LITTLE SEEDS CHILD CARE JSP25-23

Public Hearing at the request of Little Seeds for consideration of a Special Land Use Permit and Preliminary Site Plan approval. The subject property, 49700 Ten Mile Road, is an existing daycare center on a 2.25-acre parcel within the RA, Residential Acreage Zoning District. The applicant is proposing to expand enrollment at the daycare center from 60 students to 75 students and expand the parking lot by six parking spaces.

PLAN REVIEW CENTER REPORT

Re: **Little Seeds Parking Lot Expansion – Preliminary/Final Site Plan Submittal (JSP25-23)**

SITE PLAN FOR LITTLE SEEDS PARKING LOT EXPANSION

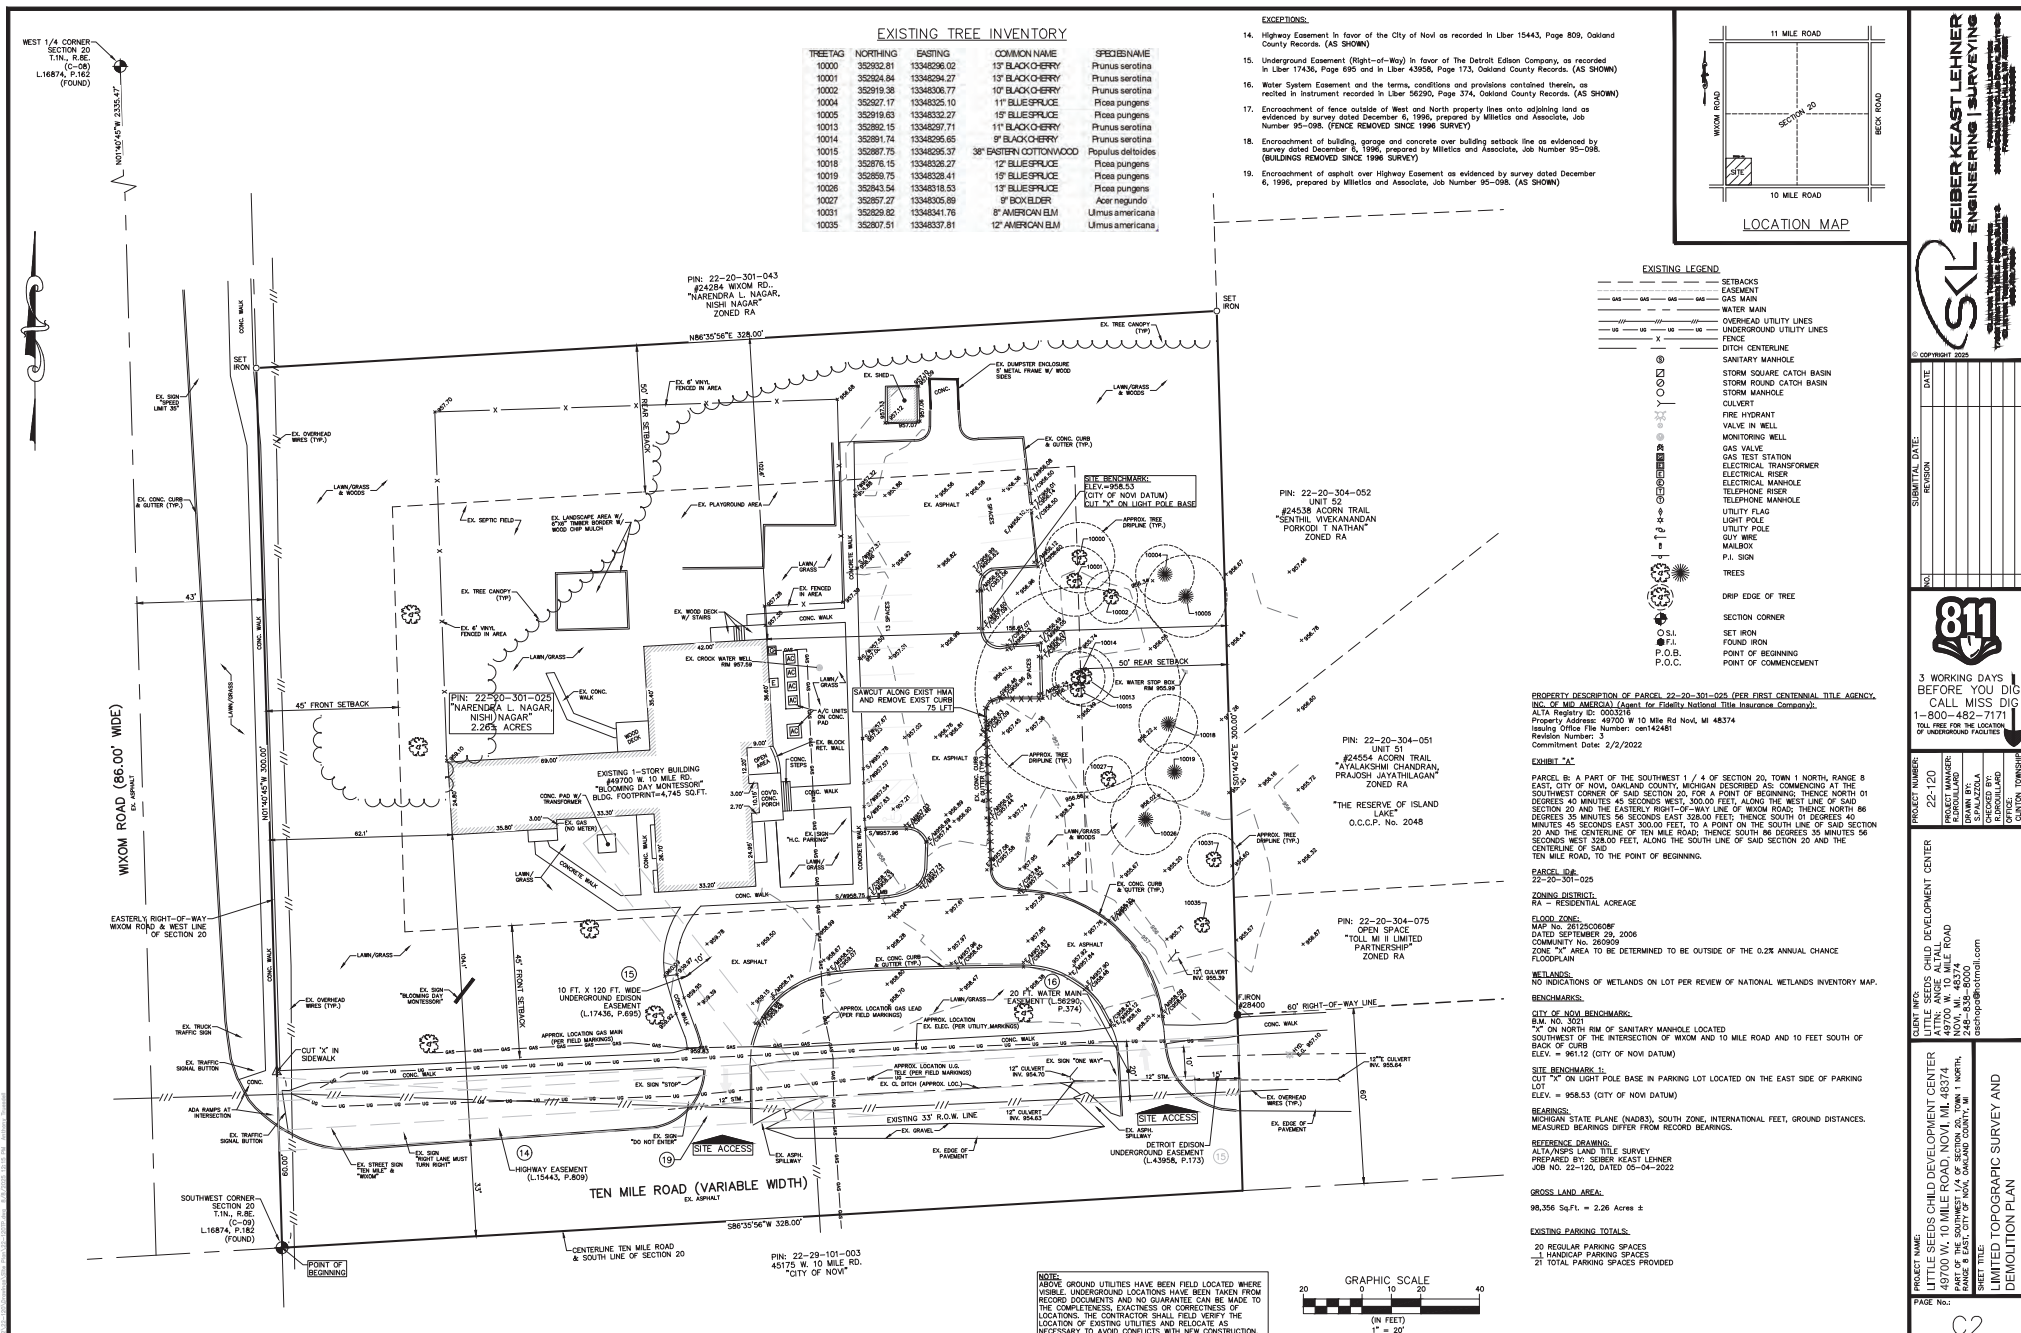
1. No new above-ground stormwater detention pond is proposed.
2. No indication of any Phragmites or Knotweed was noted on the plans. Please survey the site and show any stands of either weed on the plans along with instructions for its treatment and removal. If none is found, please add a note stating this.

1. The proposed landscaping must be provided with sufficient water to become established and survive over the long term.
2. Please provide an irrigation plan or note how this will be accomplished if an irrigation plan is not provided on Final Site Plans.

9. Phragmites Control: A note has been added to sheet C3 indicating that any Phragmites or Japanese Knotweed found on the site will need to be completely removed.

10. Irrigation Plan: There is no existing irrigation system on site and no system proposed as part of this project. A note has been added to sheet C3 indicating that tree bags will be utilized for watering the proposed trees.

Figure 1 – City of Novi Wetland and Woodland Map
Figure 2 – Wetland Boundary Determination Site Visit Map
Attachment A – Wetland Resource Documents
Attachment B – Site Photographs

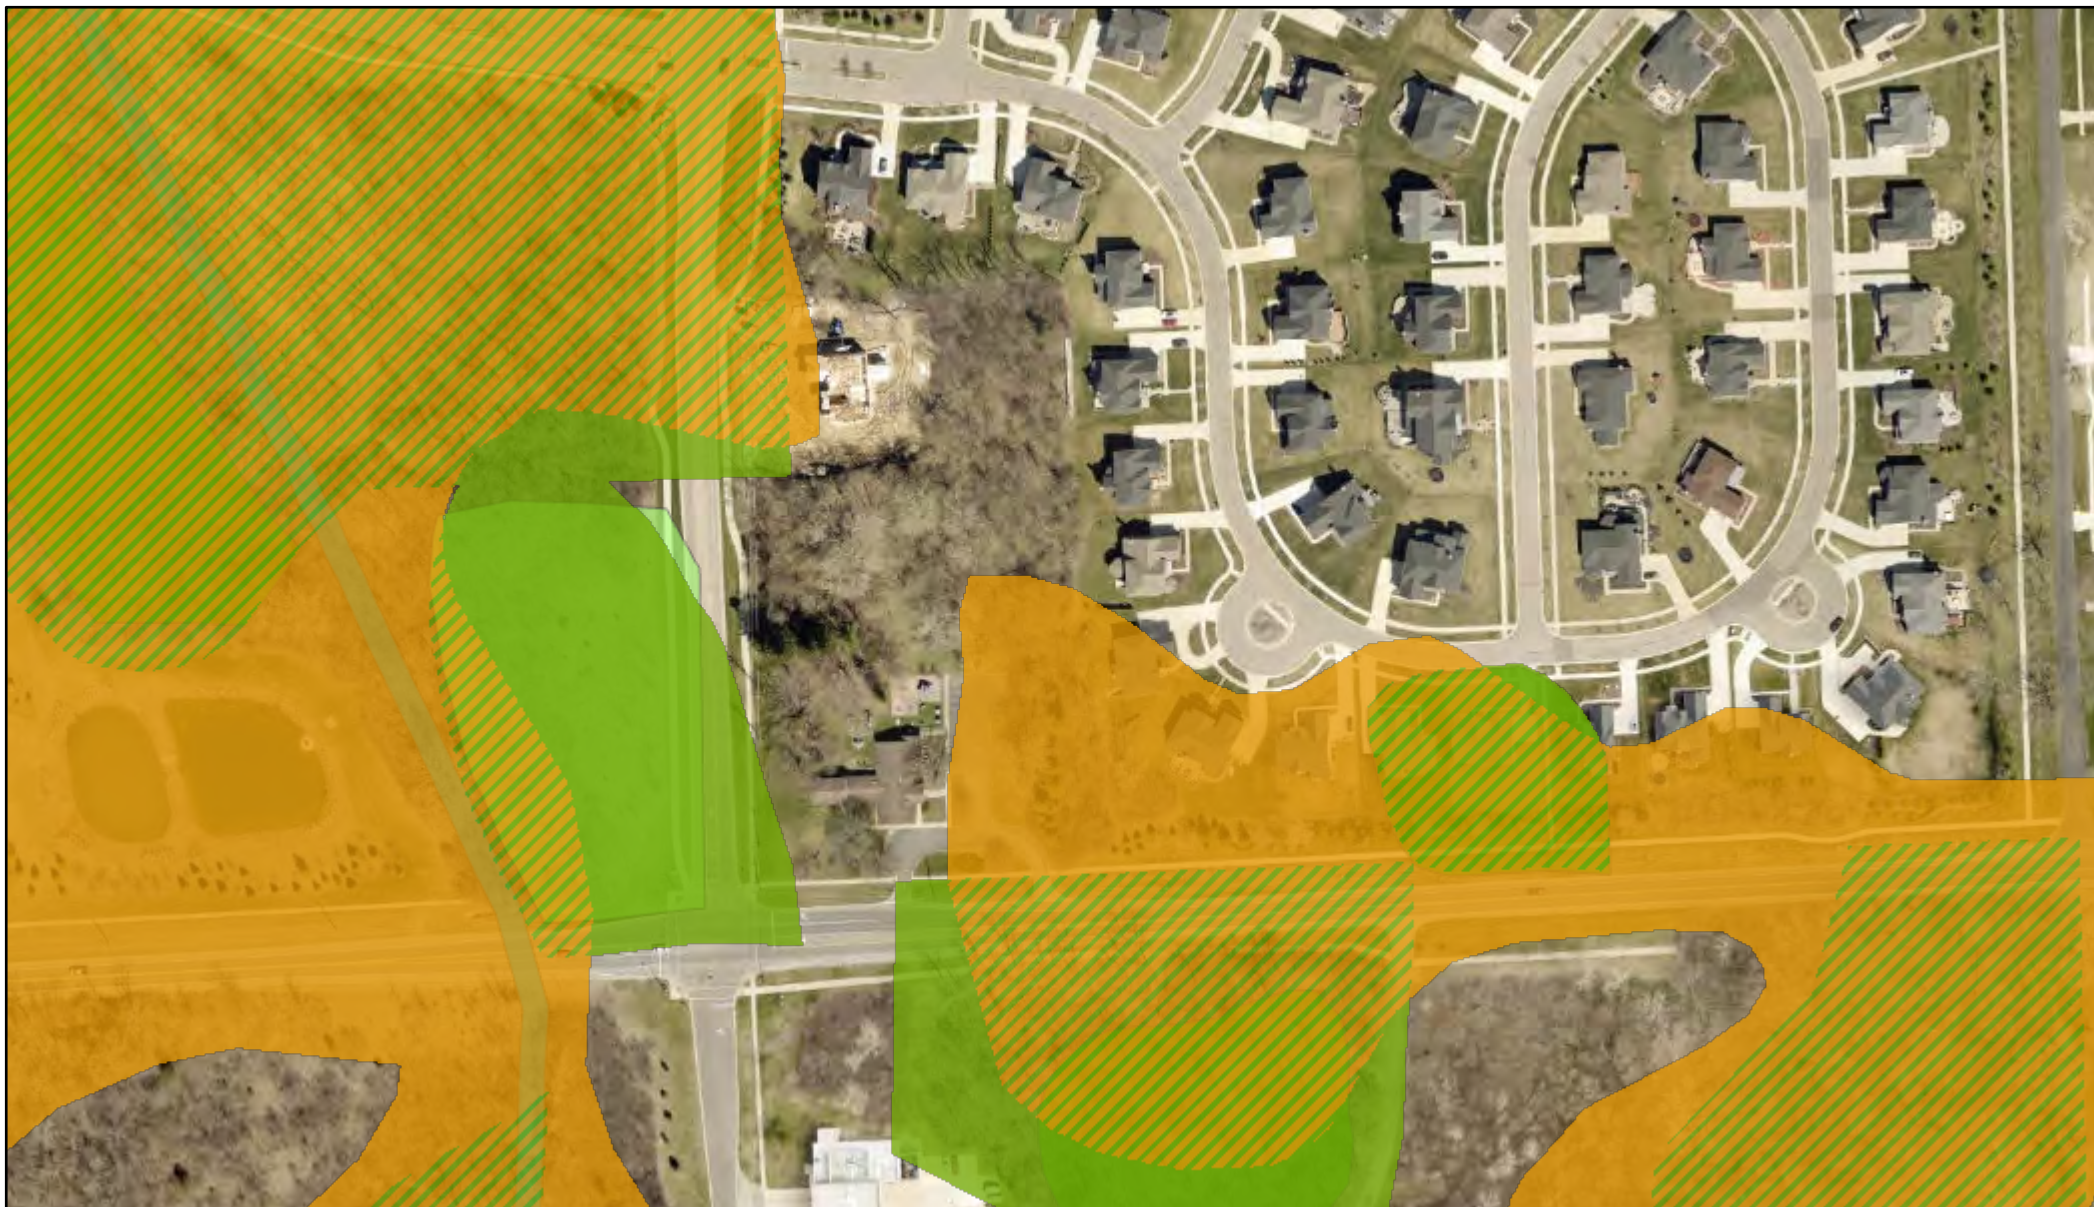
- ☐ City-regulated wetlands, as identified on the City of Novi interactive map website. Note that both wetland and property limits depicted on the City's map are considered approximations (**Figure 1**).

- ☒ City-regulated woodlands, as identified on the City of Novi interactive map website. Note that both woodland and property limits depicted on the City's map are considered approximations (**Figure 1**).
